**TOWN OF ADDISON
BUILDING REPORT**

Facility Information: **Facility Name:** Central Fire Station
Facility Contact: Lisa Pyles **Contact Phone:** 972-450-2878

Accessology Inspector Information:
Inspector: Karen Jackson **Date:** April 10, 2017
Email: Kjackson@accessology.com

Latitude: 32.965691 **Longitude:** -96.830458
Address: 4798 Airport Parkway **City:** Addison **County:** Dallas

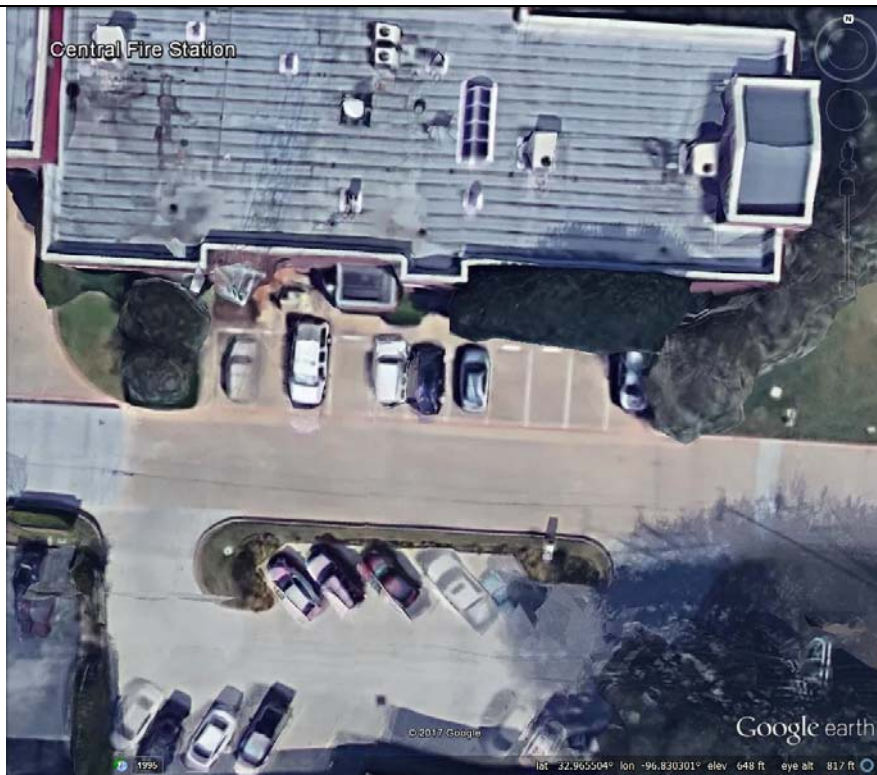
Violation 1 - The access aisle serving the front accessible parking space is only 52" wide.

Violation 2 - There is a built up curb ramp protruding into the access aisle at the front of the building.

Possible Solutions: Restripe parking to provide an access aisle that is a minimum of 60" wide.

Possible Solutions: Remove the built-up curb ramps and modify sidewalk for a parallel type curb ramp.

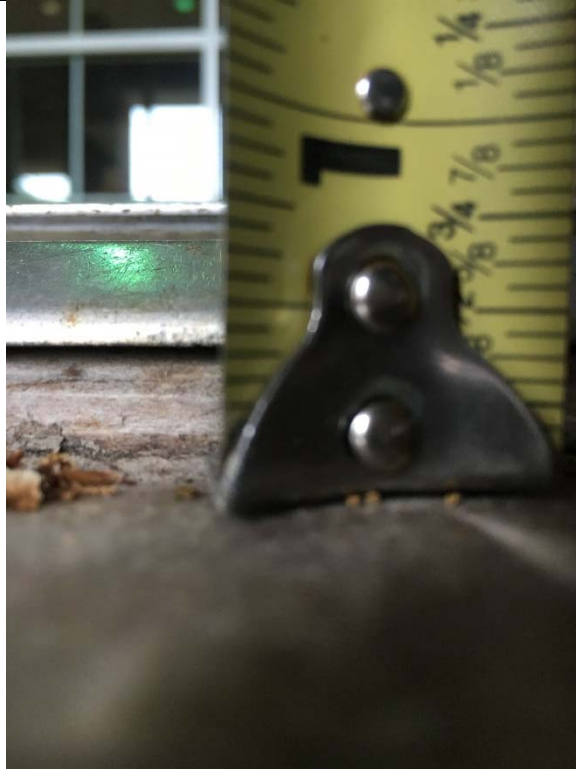
Violation 3 - There are no accessible parking spaces provided in the lot at the side of the building.

Violation 4 - There are no accessible parking spaces provided in the back lot.

Provide one van accessible parking space, an access aisle and compliant signage. See general Notes

Provide one van accessible parking space, an access aisle and compliant signage. See general Notes

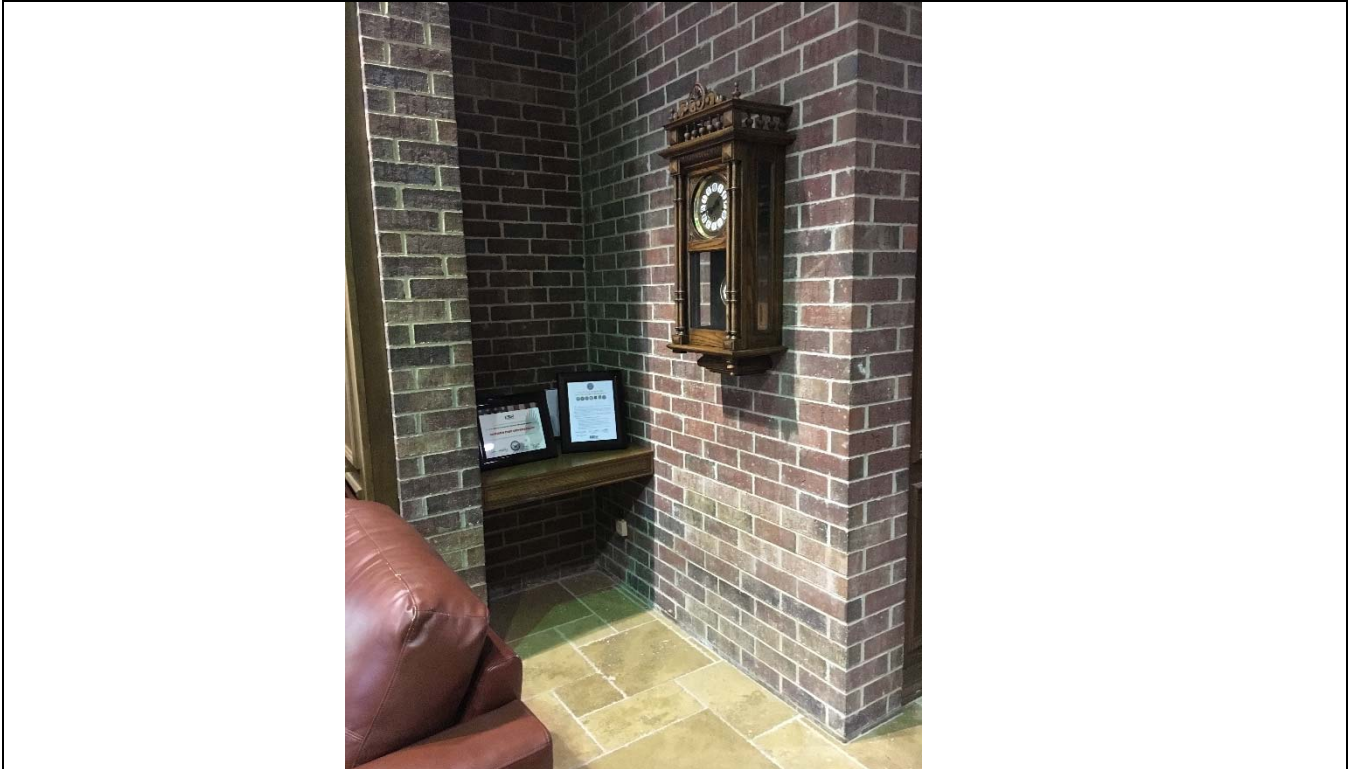
Violation 5 - The threshold at the main entrance is 3/4" where a max of 1/2" is allowed.

Modify threshold to achieve a change in level no greater than 1/2".

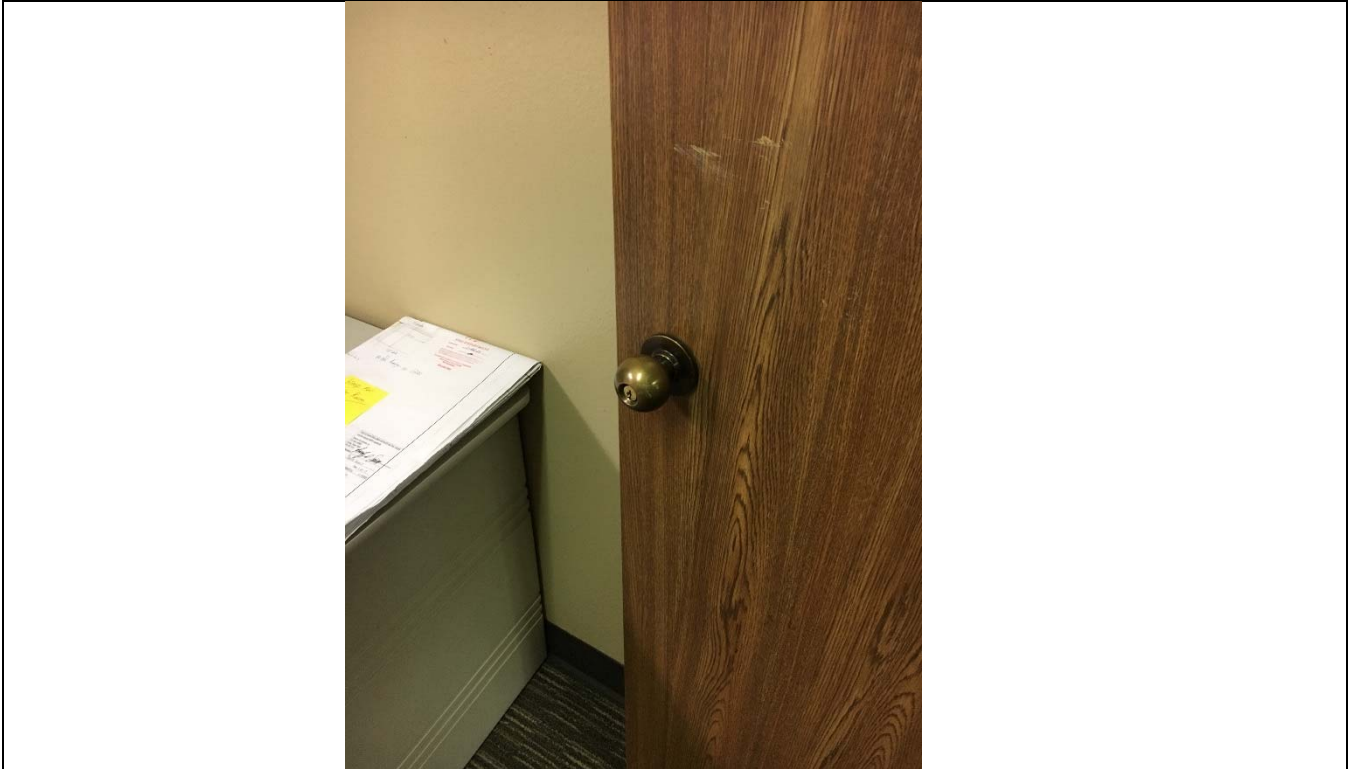
Violation 6 - The assistance phone (55.5") and push button (49") provided in the entrance vestibule are mounted above the 48" maximum reach range requirement.

Violation 7 - There is an information counter in the lobby is accessible to the public. The path to this counter has a clock mounted on the wall and is a protruding object.

Lower assistance phone and push button so the highest operable parts are at 48".

Relocate clock. No cost is associated with this as the clock is not permanently mounted.

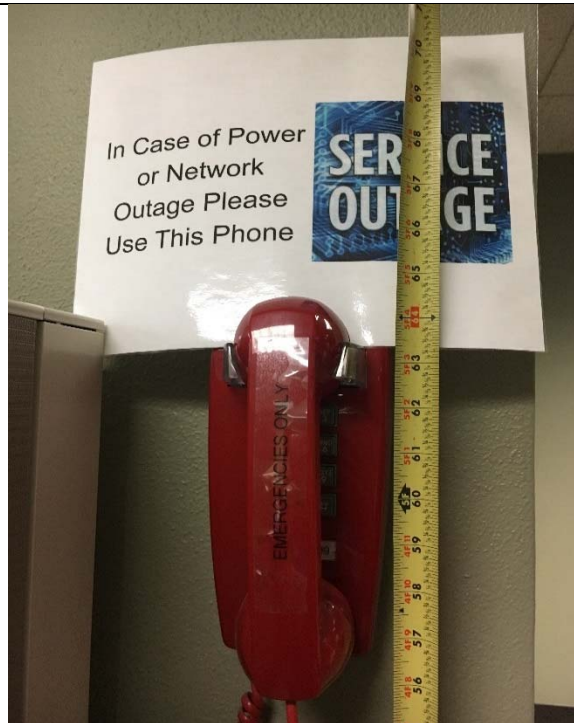
Violation 8 - There are approximately 30 doors throughout this facility with door hardware that requires grasping and twisting of the wrist to operate.

Violation 9 - There are 12 room signs that are not compliant throughout the facility. They are mounted in the wrong location and do not have Braille or tactile characters. All room signs need to be replaced to provide consistency and accuracy of the spaces they designate.

Replace with lever style door hardware.

Provide compliant signage for all permanent rooms.

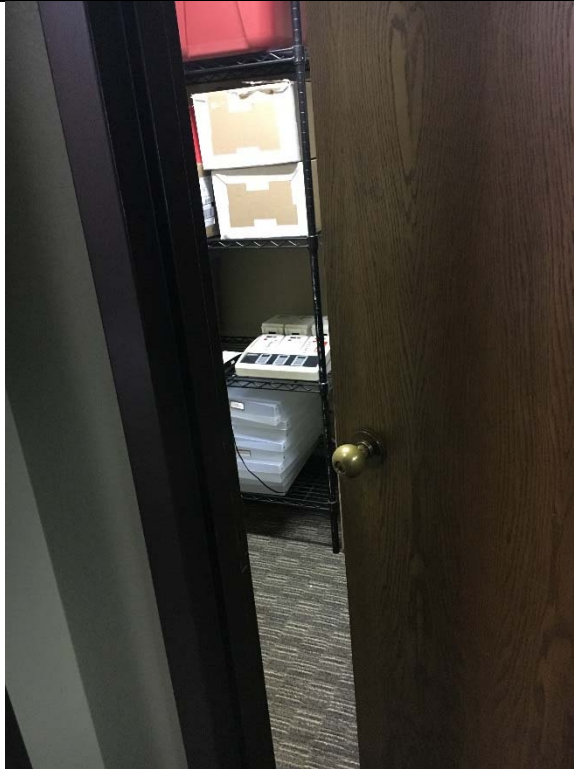
Violation 10 - The work room only has a 4" maneuvering clearance on the pull side of the door, a minimum of 18" is required.

Violation 11 - The surge outage phone's highest operable part is at 61 3/4" where a maximum high reach is 48".

Reverse swing of the door.

Lower phone so the highest operable part is at 48".

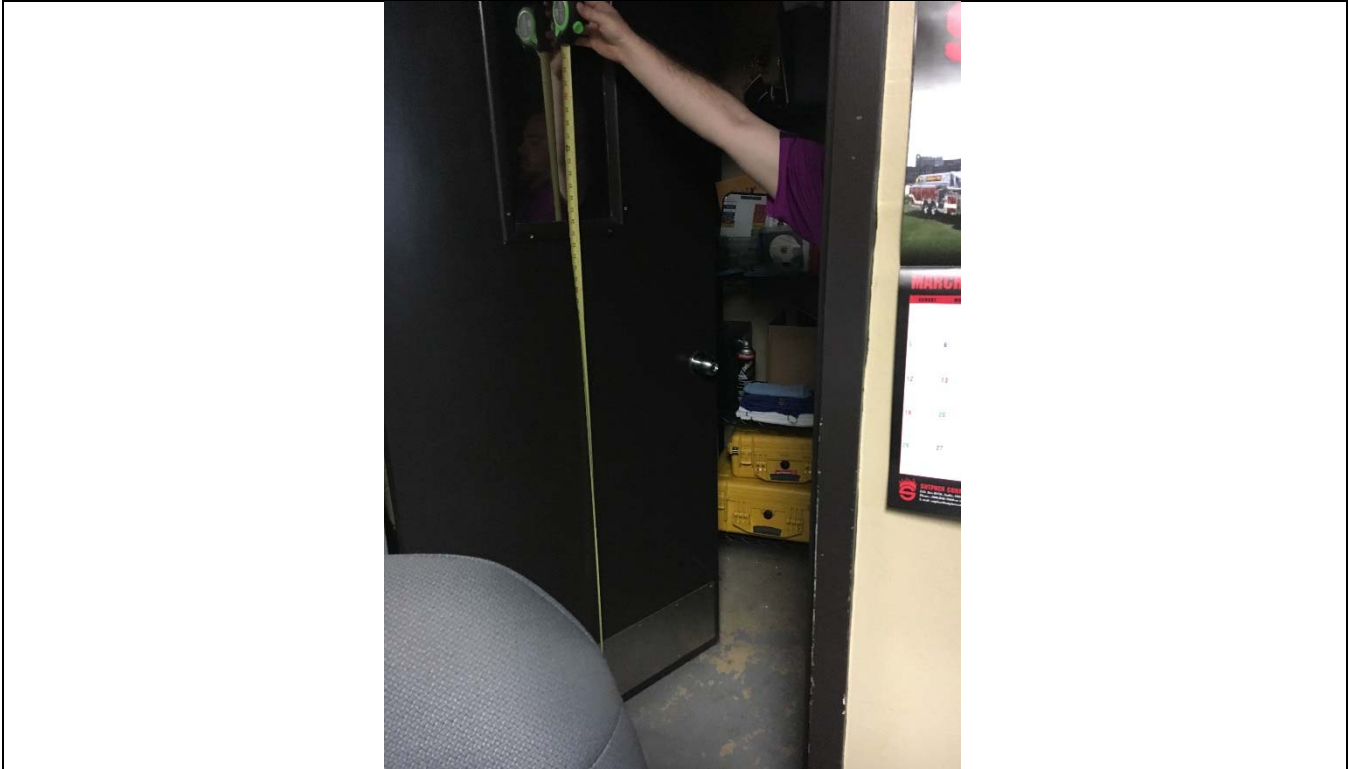
Violation 12 - The door into the EMS Room only has a 29" wide opening, a minimum of 32" is required.

Violation 13 - The door for the CAPT/LT room only has a 31" wide opening, a minimum of 32" is required.

Violation 14 - The work room in the back of the training room has a door with a 29" wide opening, a minimum of 32" is required.

Violation 15 - The storage room door only has a 28" wide opening and a 16.5" maneuvering clearance on the pull side.

Violation 16 - The door leading from the bay into the sleeping quarters only has 5.5" maneuvering clearance on the pull side where a minimum of 18" is required.

Violation 17 - The door leading from the bay into the hallway area only has a 2.5" maneuvering clearance on the pull side where a minimum of 18" is required.

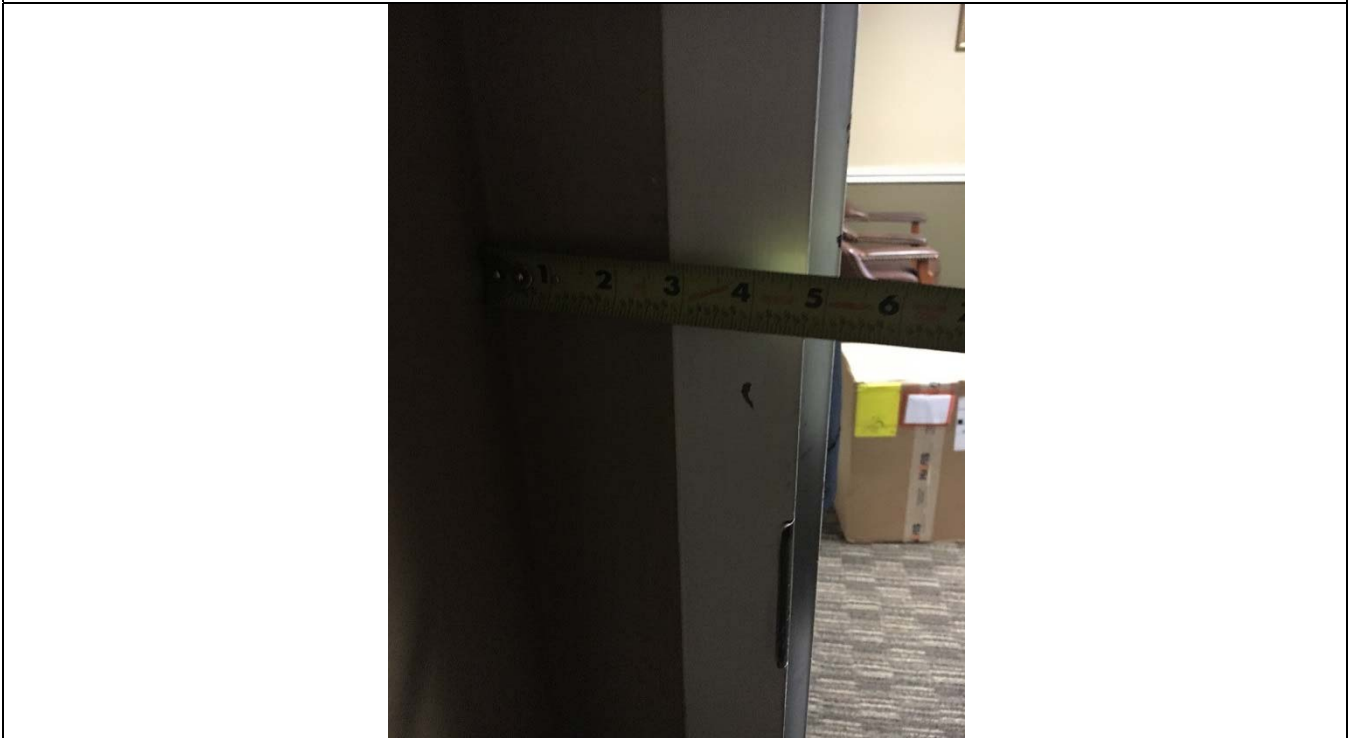
Violation 18 - The door leading from the hall into the sleep quarters only has a 6" maneuvering clearance on the pull side where a minimum of 18" is required.

Violation 19 - The closet in the CTP/LT room has a vision panel that is at 54", a maximum of 43" is required.

Modify door to provide 18" clearance.

Replace door that has a vision panel at 43".

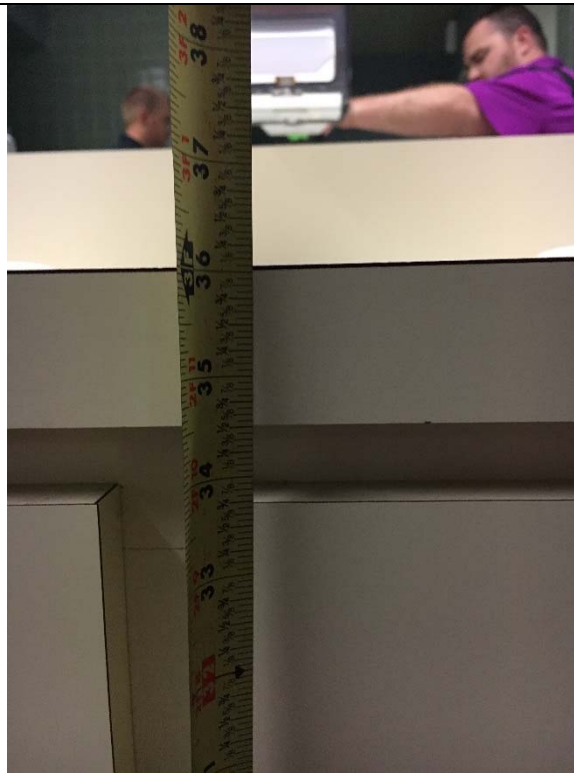
Violation 20 - Office only has a 5" maneuvering clearance on the pull side of the door where a minimum of 18" is required.

Violation 21 - Single sleep room door opening is only 29" wide where a minimum of 32" is required.

Violation 22 - Men's & Women's restrooms do not have accessible toilet compartments.

Violation 23 - Men's & Women's restrooms lavatory pipes are not protected from contact.

Violation 24 - Men's shower room does not have an accessible toilet compartment.

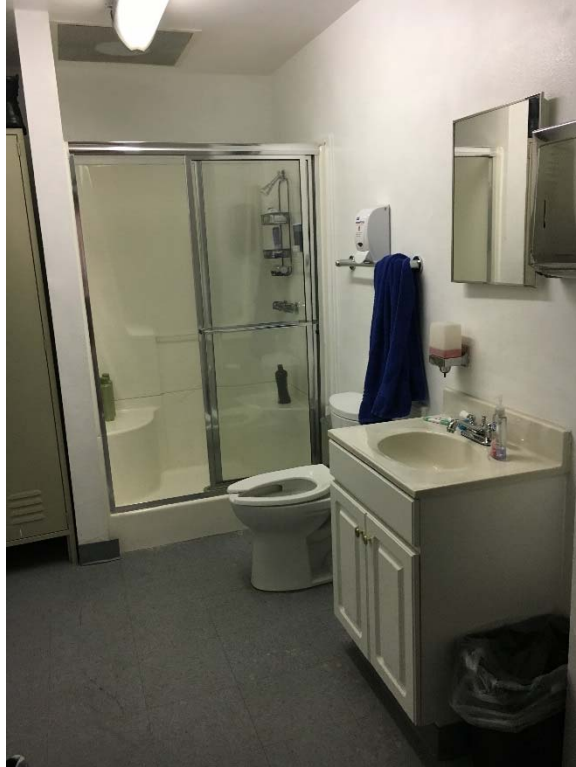
Violation 25 - Men's shower room does not have any accessible urinals.

Violation 26 - Men's shower room lavatory counters are at 36" with no knee clearance provided.

Lower one of the urinals so it is at 17" to the rim.

Modify lavatory to provide required toe and knee clearance and a 34" maximum height.

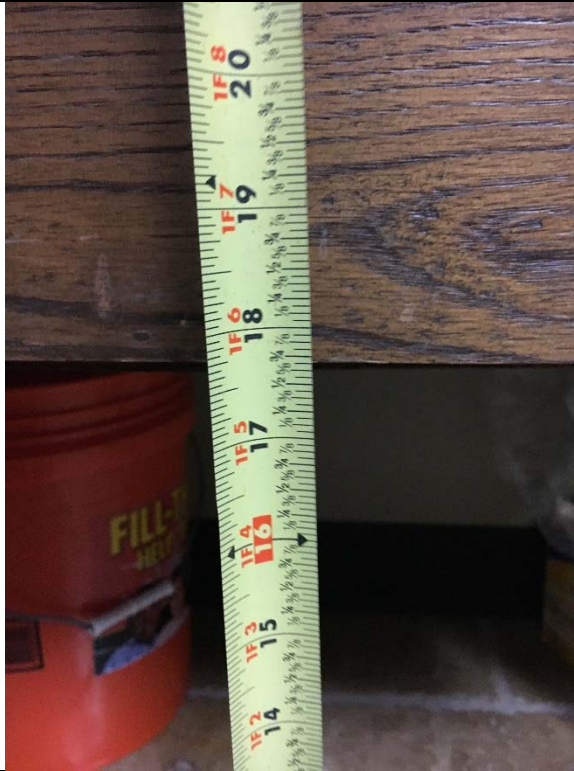
Violation 27 - Men's shower room – Does not provide an accessible shower. There is a 7" curb leading into the shower area. Additionally, none of shower areas have compliant controls.

Violation 28 - Women's shower room is not large enough to accommodate a wheelchair turning space and the required clear floor space for each feature.

Provide an accessible shower.

Remodel shower room to provide a 60" clear turning radius and a compliant shower, water closet and lavatory.

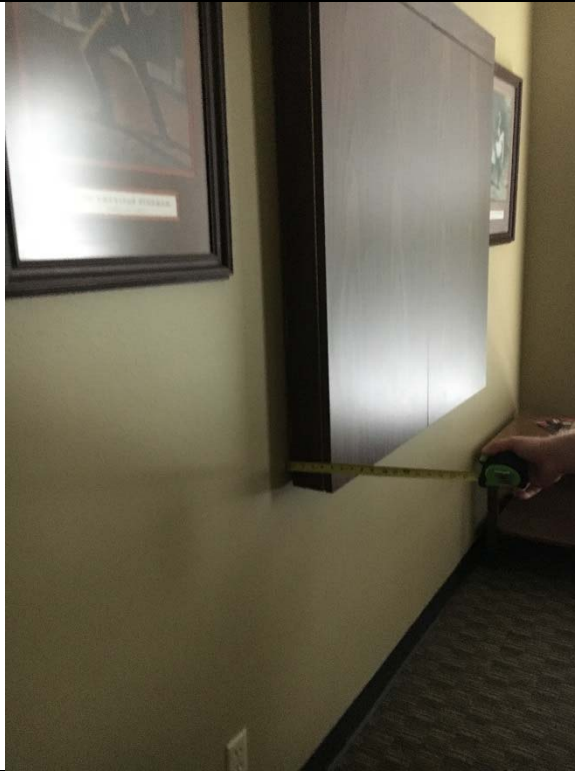
Violation 29 - The phone in the break room is a protruding object and is mounted with the highest operable part above 48".

Violation 30 - The sink in the break room is mounted at 39 5/8" with a knee clearance that is only 17-1/2".

Violation 31 - The break room sink controls require grasping and twisting to operate.

Violation 32 - The kitchen does not have a lowered section or workspace provided.

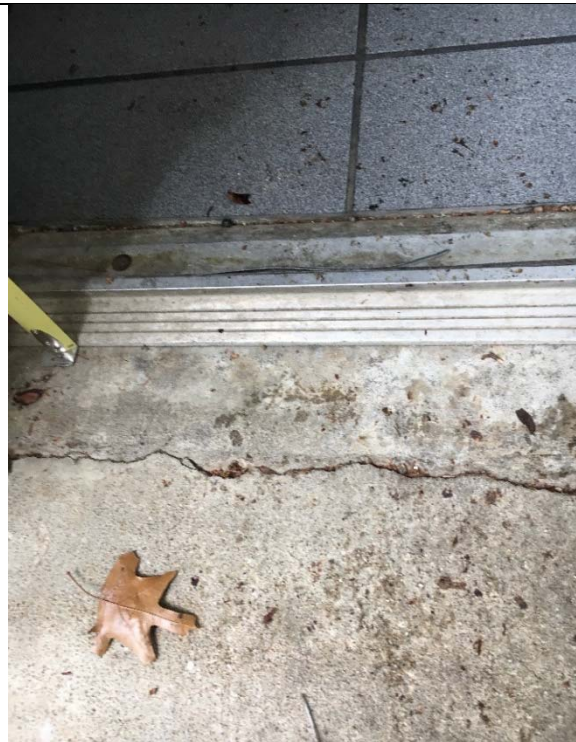
Violation 33 - The sink in the kitchen is not complaint. It has no knee clearance and is at 35 3/4".

Violation 34 - The white board in the conference room protrudes 4.5" into the circulation path at 35 3/4" above finished floor and is considered a protruding object.

Violation 35 - The thermostat is mounted with the highest operable part at 59.5" where a maximum reach range is 48".

Violation 36 - Outside the restrooms, there is only one drinking fountain provided, two are required.

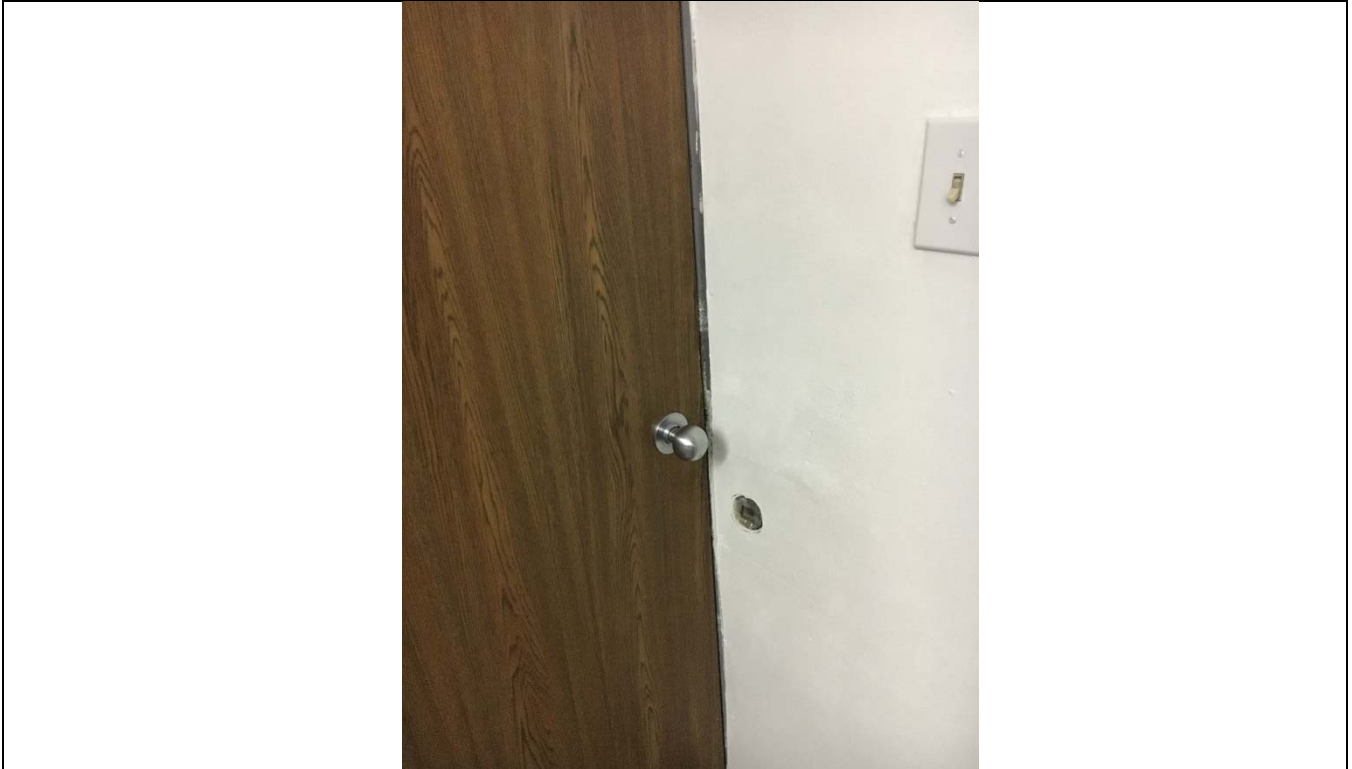
Violation 37 - The phone provided in the training room is mounted with the highest operable part at 55" and protrudes into the circulation path 5".

Violation 38 - The threshold going into the kitchen from the outside patio area is 5/8" where a max of 1/2" is allowed.

Relocate phone and mount it so the highest operable part is at 48".

Modify threshold to achieve a change in level no greater than 1/2".
